**REZONING AND FINAL DEVELOPMENT PLAN, FINAL PLAT APPROVAL, WILDER, LANE,
PLATTE CANYON PARTNERS, LLC, APPLICANT.**

I. Purpose and Location

This is a request for Final Plan and Final Plat approval for twenty-four (24) single family lots (patio homes) on a 6.62 acre site. The property contains two contiguous parcels; a west parcel (4.33 acres), owned by Nelson Real Estate Properties, Inc., which fronts on Platte Canyon Rd., and an east parcel, (2.29 acres, former Jurgelonis property), which fronts on Middlefield Rd. It is proposed to rezone both parcels to Residential Planned Development (RPD).

PARKING EXHIBIT - ON-STREET - 2 SIDES

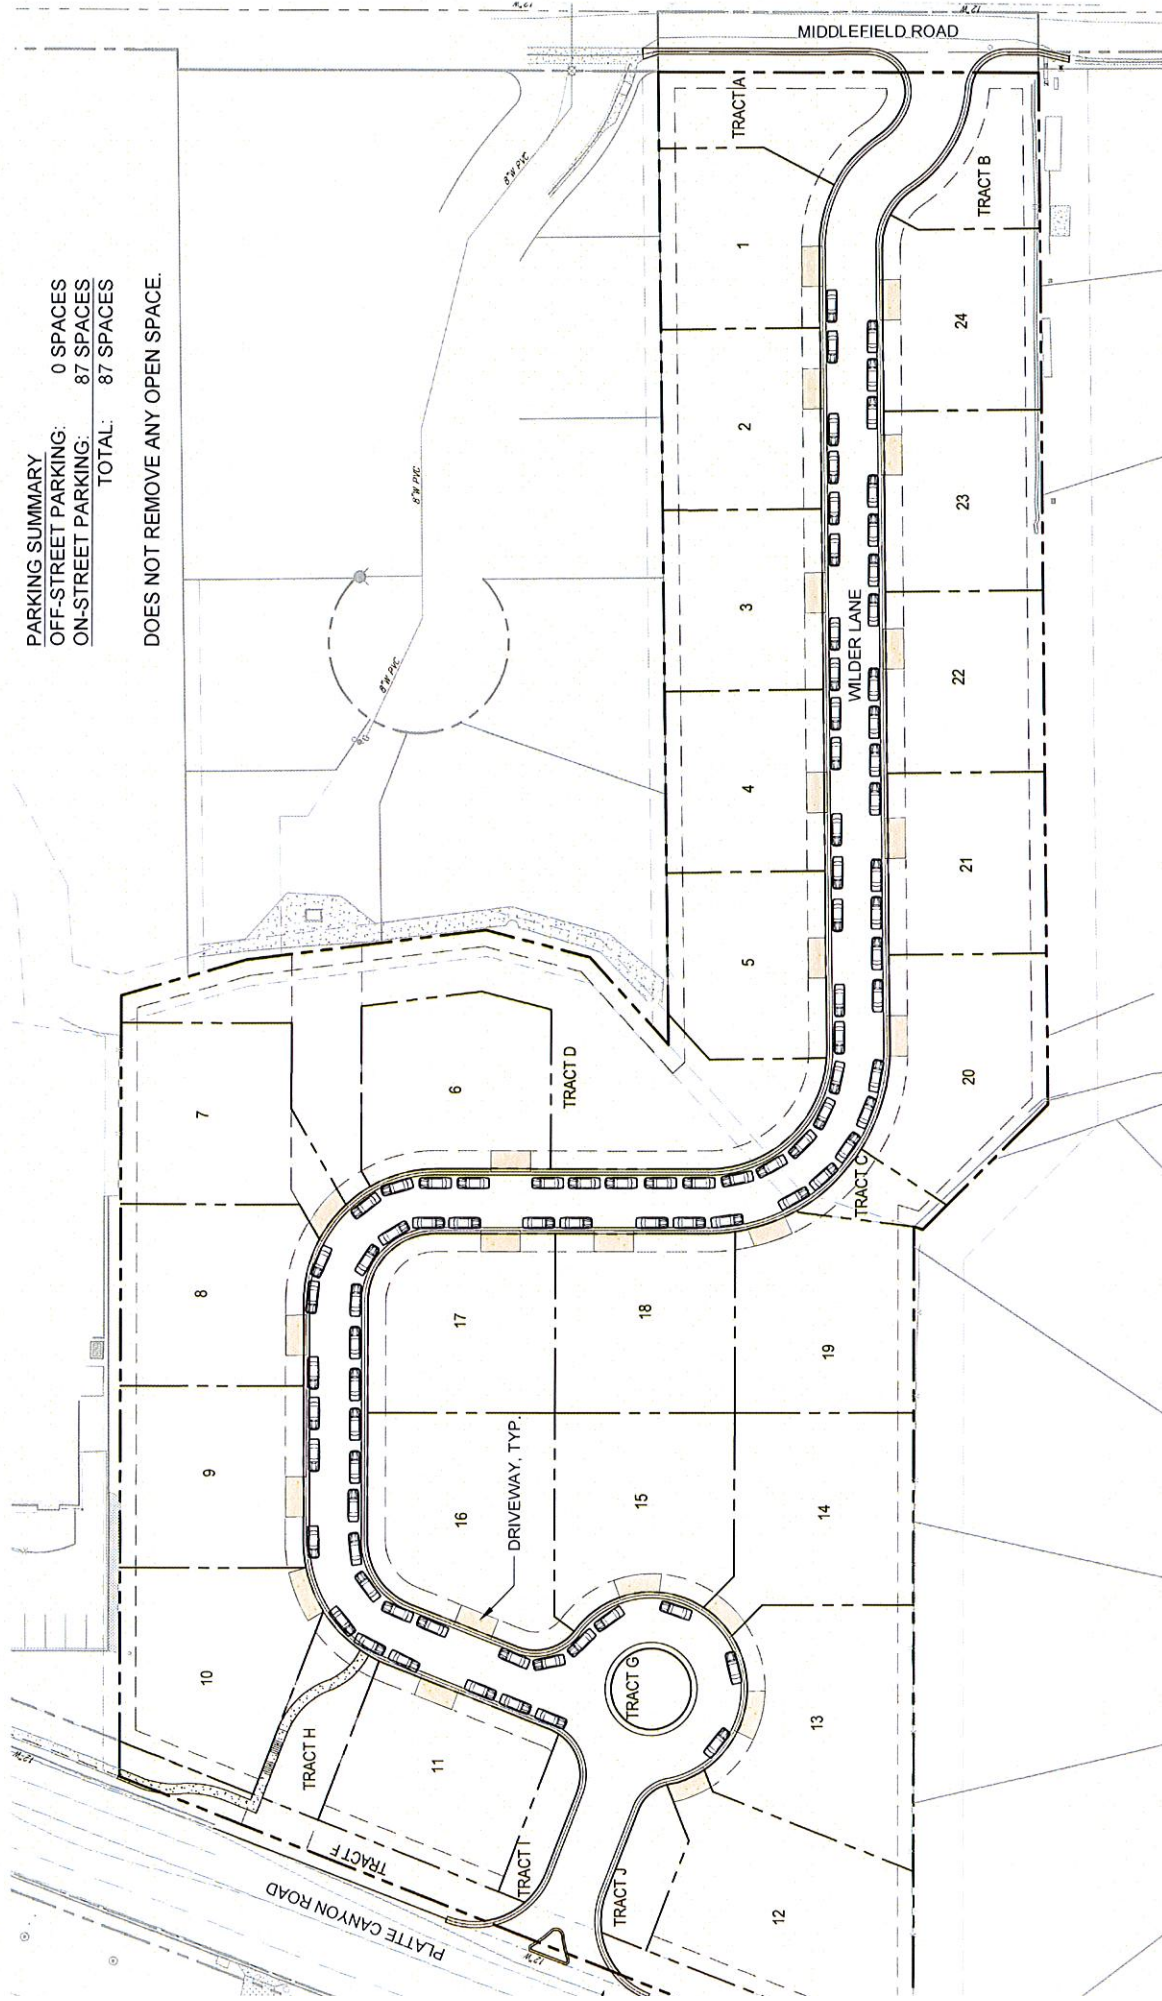
Exhibit A-1. The total number of on-street spaces that would be available without modification of the preliminary development plan and allows parking on both sides of the street. Exhibit A-2 shows the total number of on street spaces with parking on one side only.

B-1

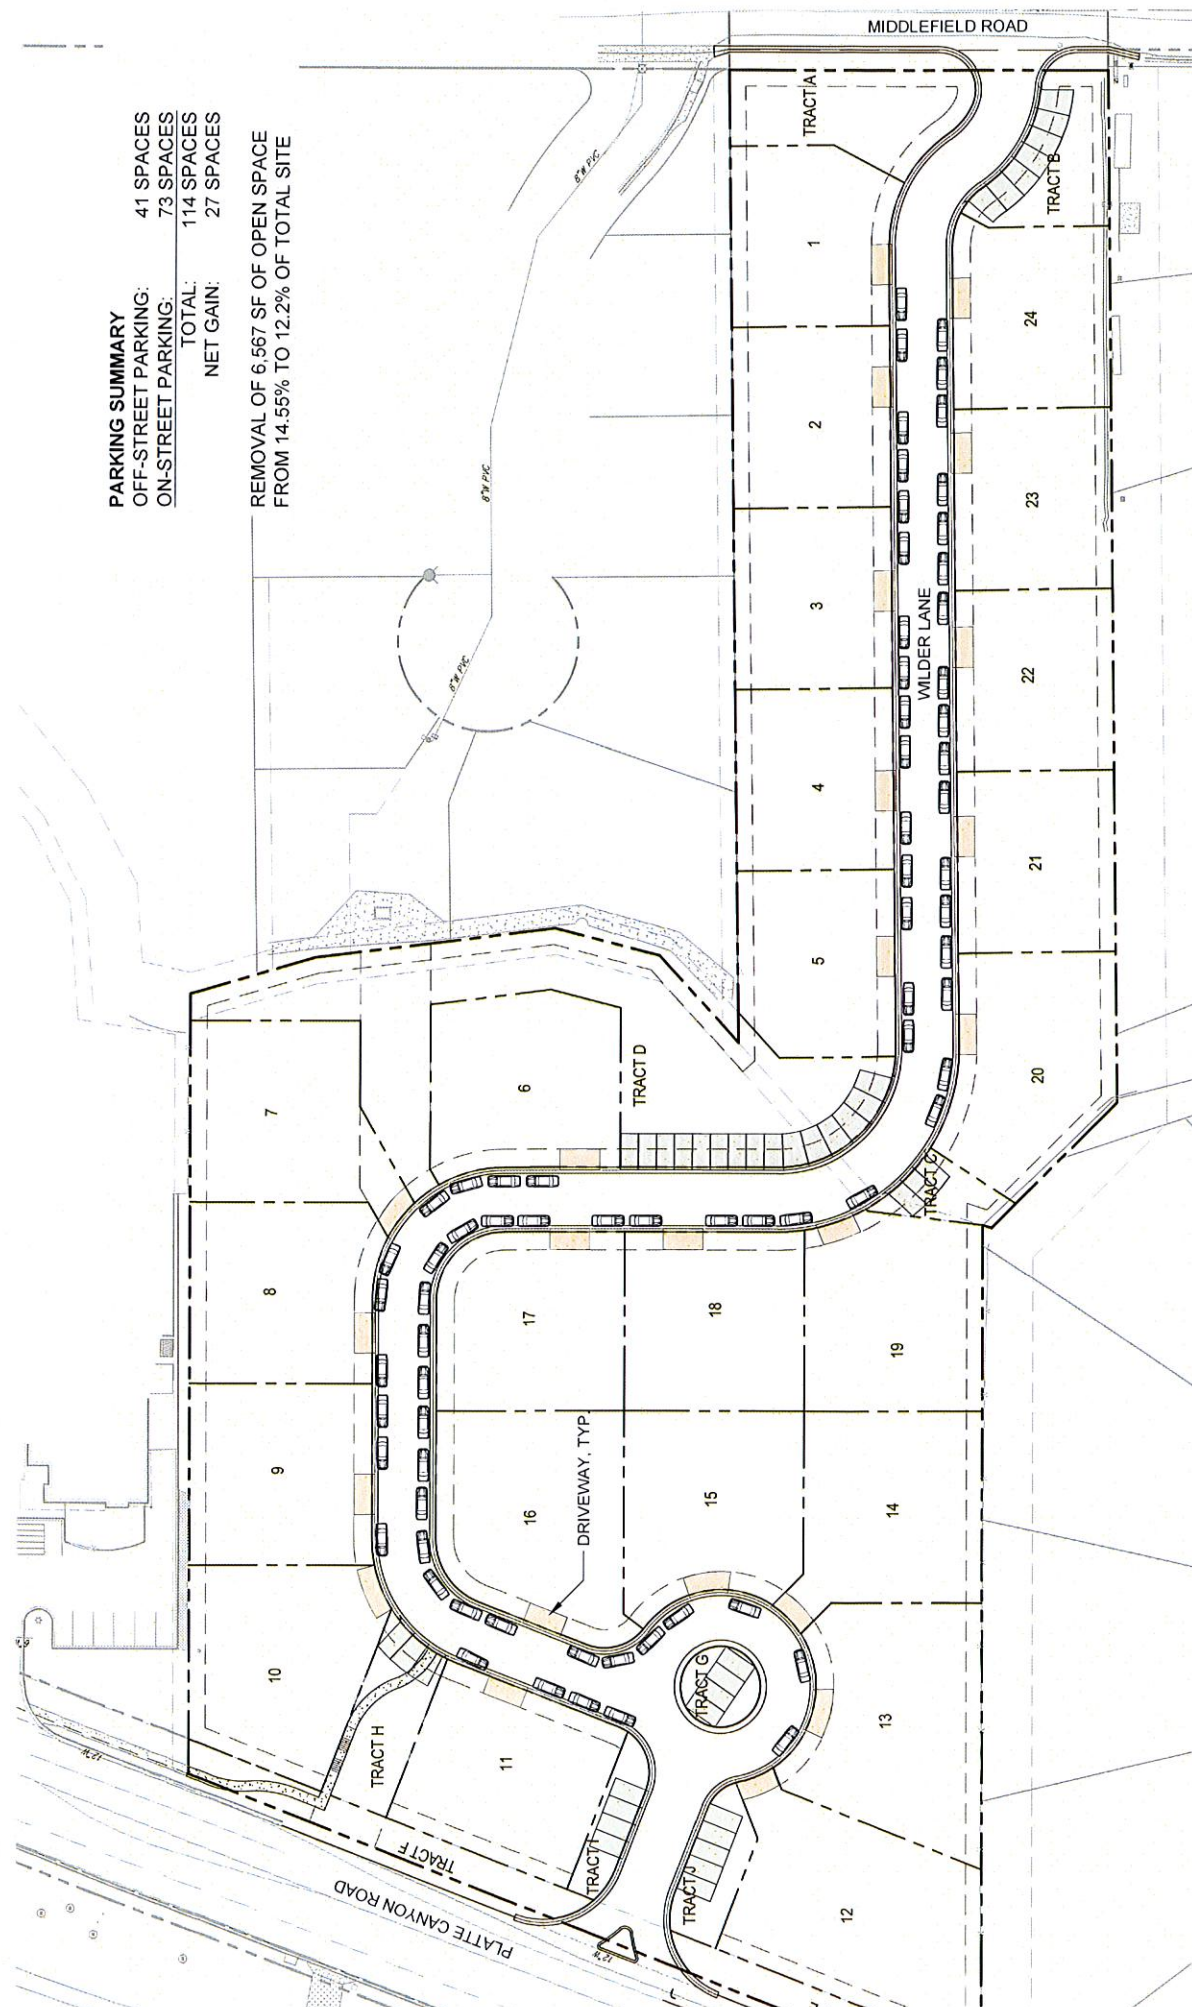
Exhibit B -1, -2 &-3. These alternatives would provide visitor parking but it would be at the expense of the approved open space percentage. Exhibit B-1 as prepared by the applicant shows a gross total of 13 off street visitor parking spaces. However, the street cuts necessary to access these spaces eliminates some on street parking so the net gain is only 3 spaces and the open space is reduced from 14.55% to 13.80%. Exhibit B-2 is a variation of this option that shows significantly more visitor parking. The gross number

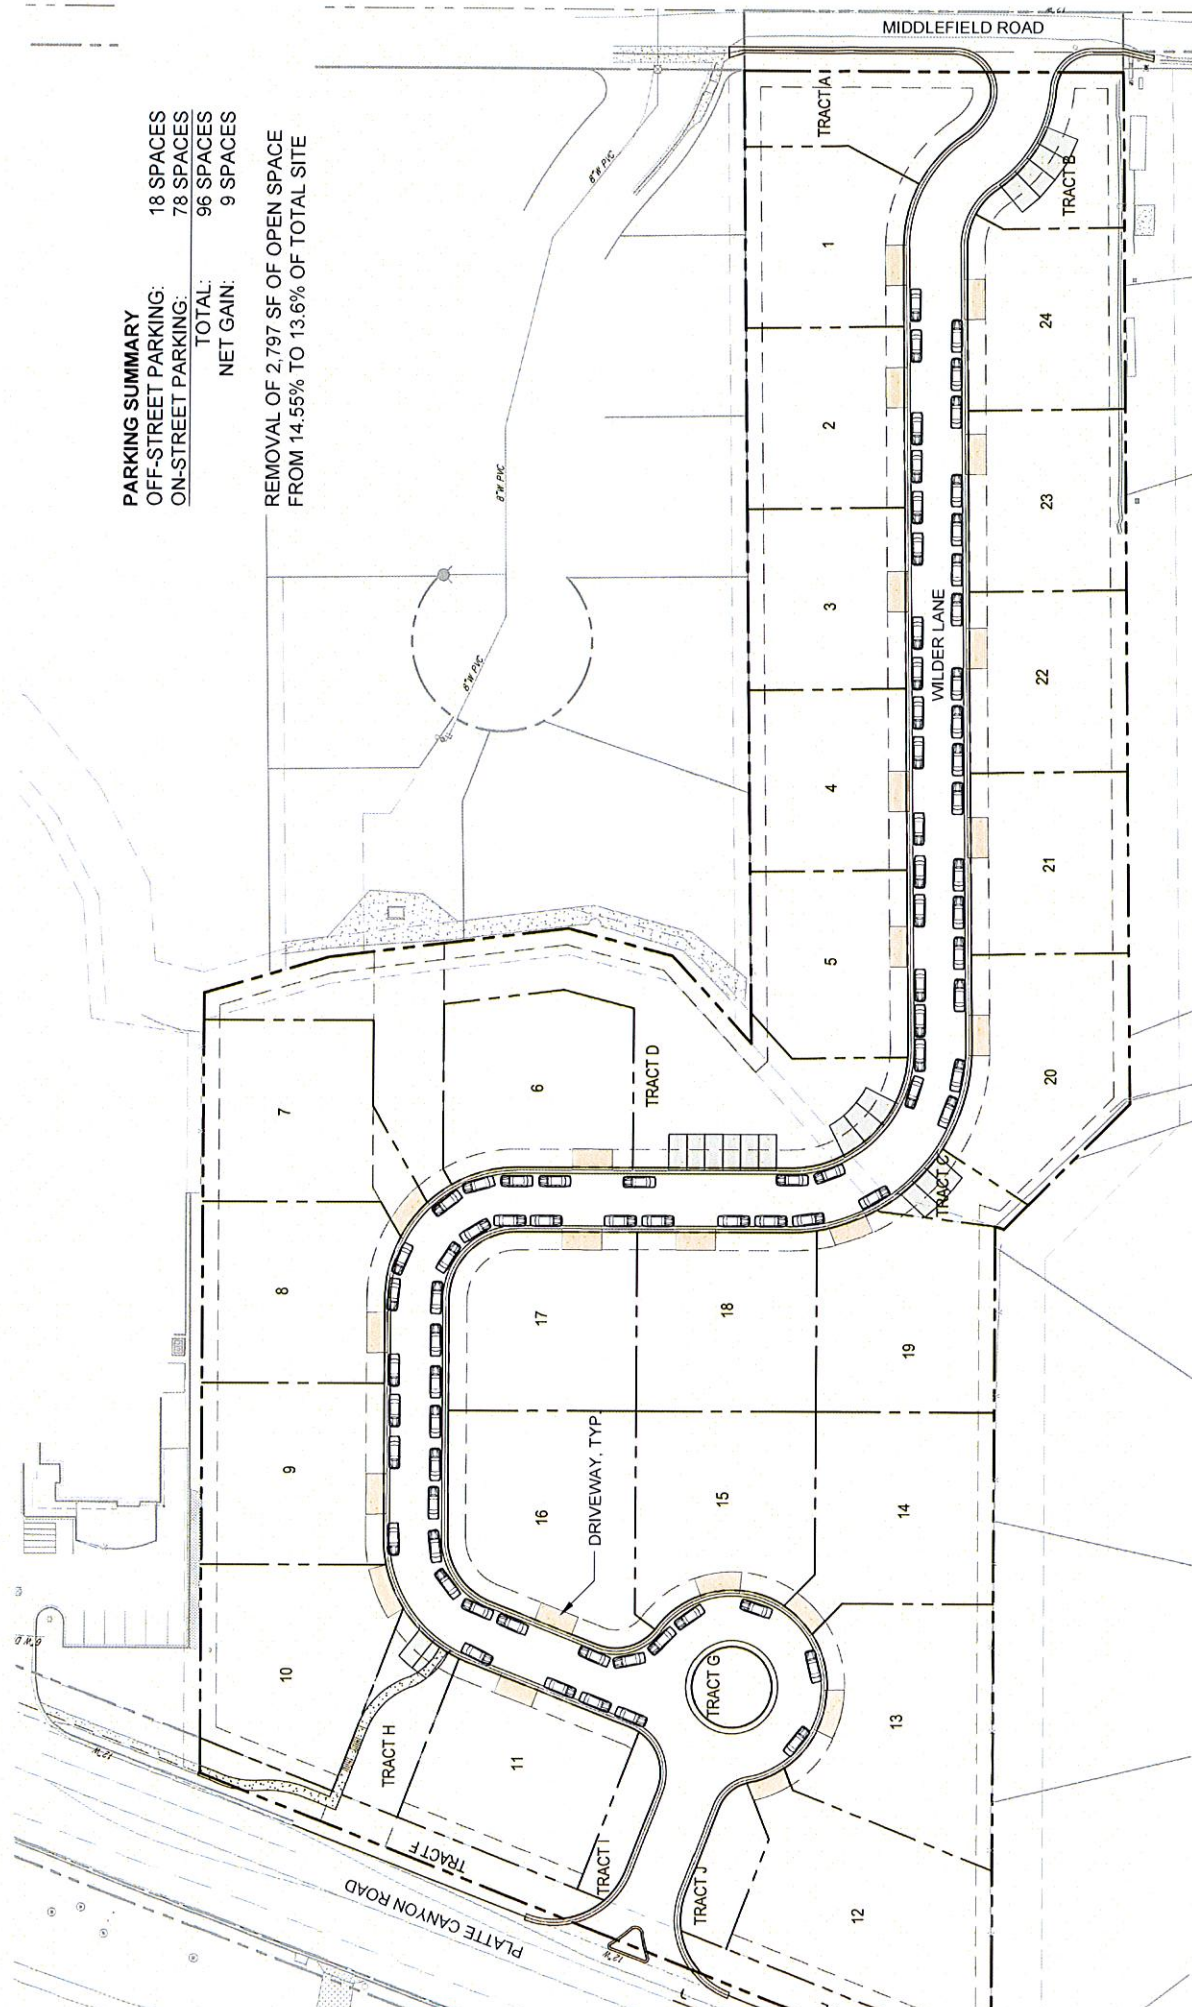
of spaces is 41 but again the net gain is 27 and the open space percentage drops from 14.55% to 12.20%. Exhibit B-3 is another variation that provides 18 visitor spaces (net 9) and the spaces are located to better serve the entire development. The open space is reduced is from 14.55 to 13.60.

Of the options provided in Exhibit B, the staff prefers B-3 in that the spaces are located to best serve the entire development and the open space reduction is less than B-2.

C PARKING EXHIBIT - EASEMENTS

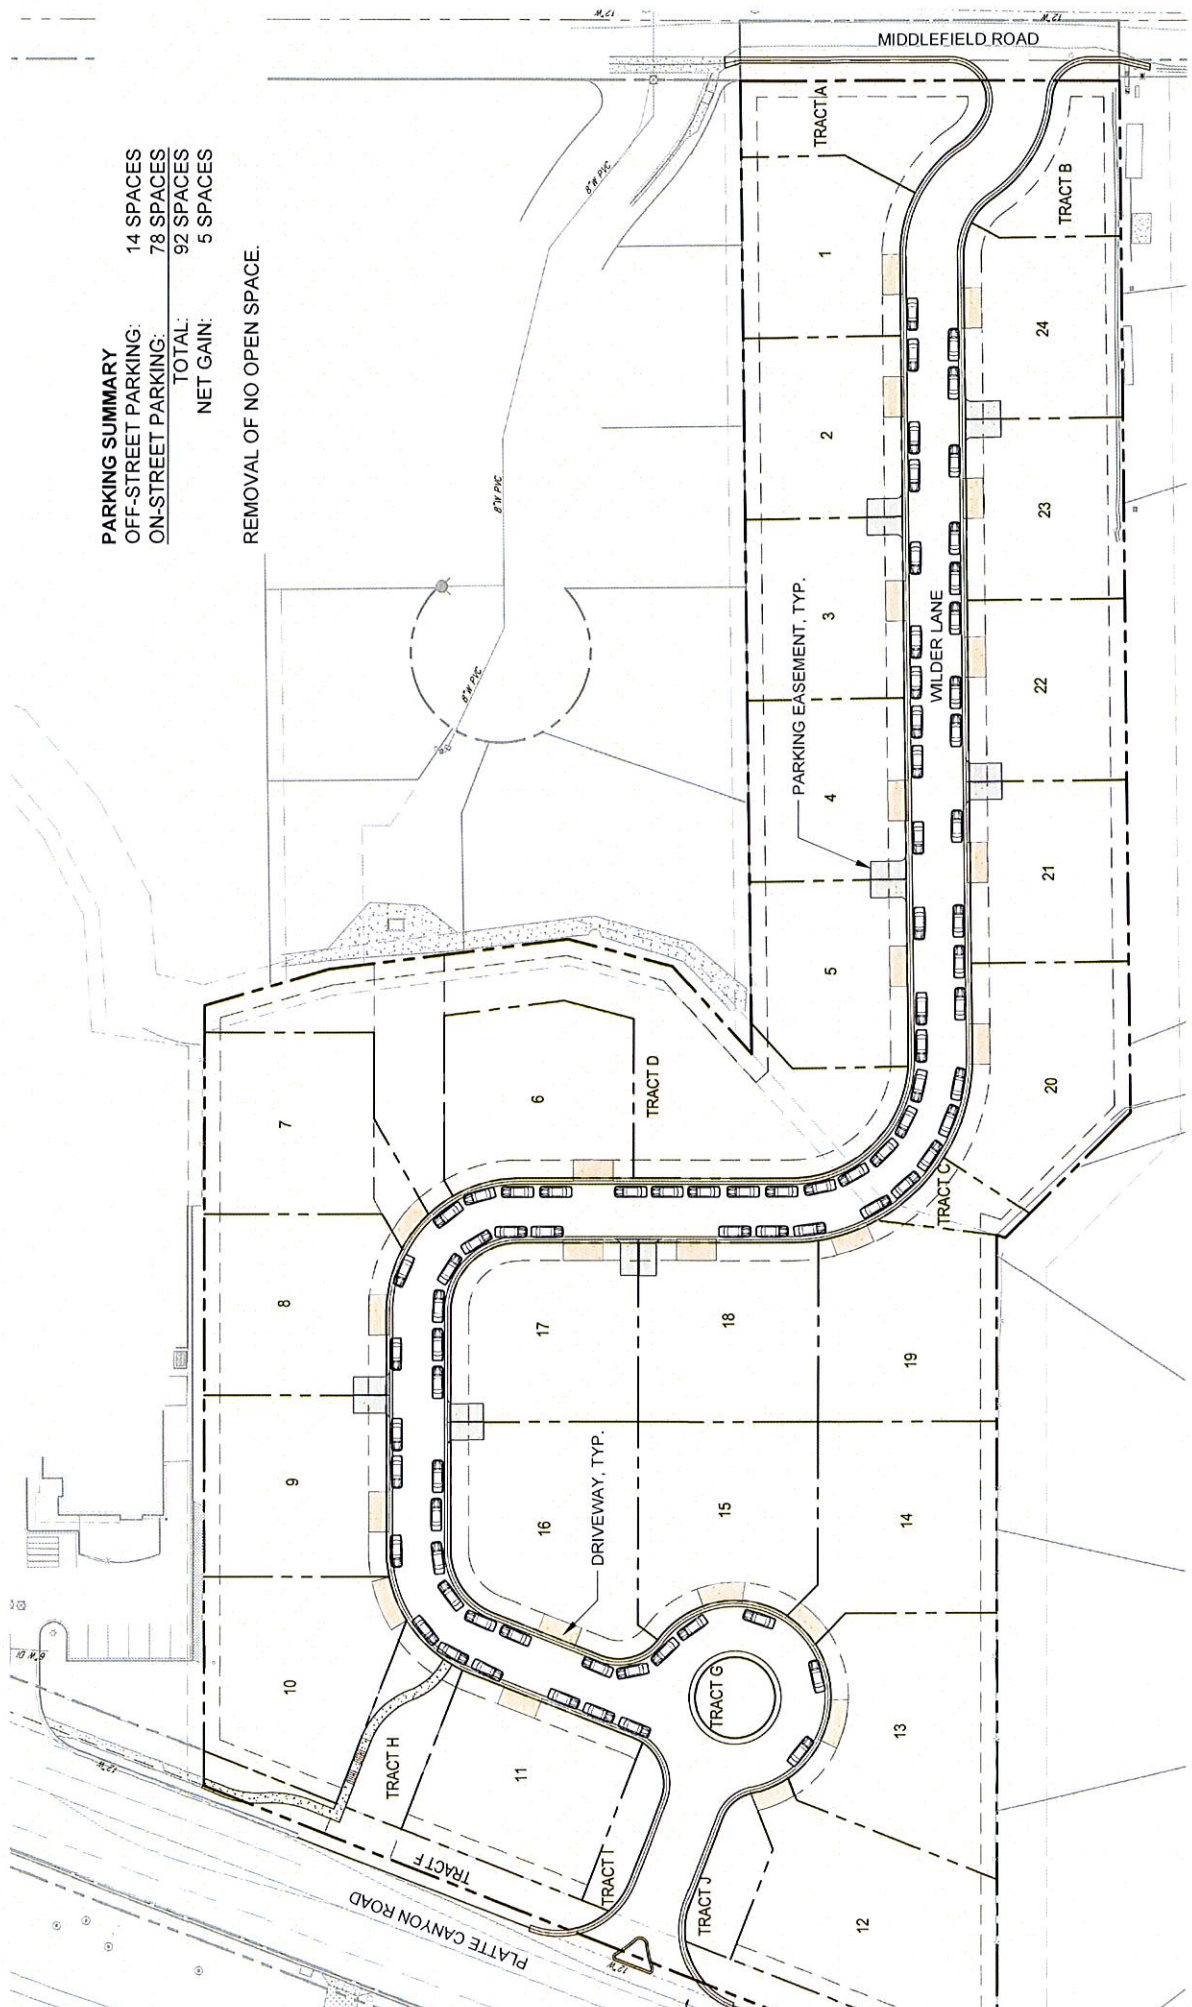
Exhibit C. This alternative shows how visitor parking could be provided without a reduction of the approved open space percentage. The Exhibit illustrates that 14 visitor spaces could be provided. This alternative would reduce the number of on street spaces so the net gain is 5. In addition this alternative creates easements which would intrude into the private lots. This could create marketing problems for the applicant and the Town Attorney has expressed a concern over potential legal issues.

Revise the final development plan and final plat to show the addition of ___ visitor parking spaces as shown on Exhibit C.
